FCC Class II Permissive Change Application Letter

Applicant's complete, legal business name:
ooma, Inc.

Equipment Product Code:
-BFLY2

XFT-BFLY2, 03/27/2019

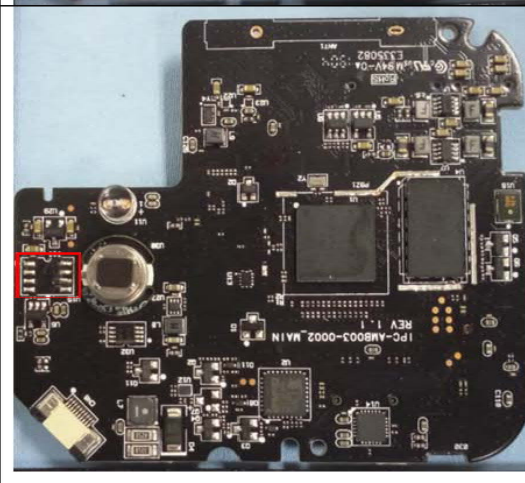
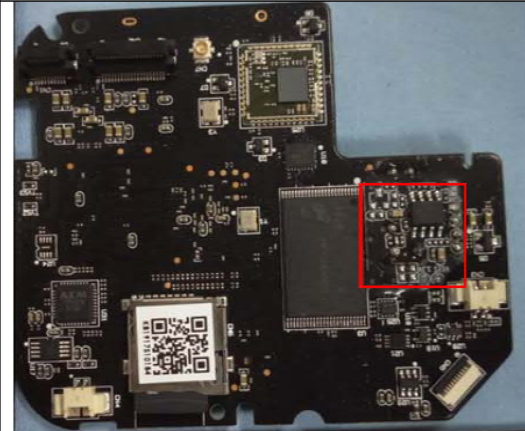
Change Contents: update the components on main board as below(The part to be modified is the peripheral circuit part of the RF module.):

Old PCB of IC: 9769A-BFLY2	New PCB of IC: 9769A-BFLY2
with U15	Delete U15
with R242 (0R $\pm$ 5% 1/20W 0201)	delete R242
with R176(100K $\pm$ 1% 1/20W 0201)	delete R176
with R178(51K $\pm$ 1% 1/20W 0201)	delete R178
without U1	add U1(AS085, SOP8 V7.01)
without C5	add C5(100pF 50V $\pm$ 10% 0402 X7R)
without C1,C3,C4	add C1,C3,C4(0.1uF 16V $\pm$ 80-20% 0402 Y5V)
without C2,C10	add C2,C10(4.7uF $\pm$ 10% 16V 0603 X5R)
without R5	add R5 (100K $\pm$ 5% 1/16W 0402)
without R6	add R6 (10K $\pm$ 5% 1/16W 0402)
without R1	add R1(47K $\pm$ 5% 1/16W 0402)
without R4	add R4(0R $\pm$ 5% 1/16W 0402)
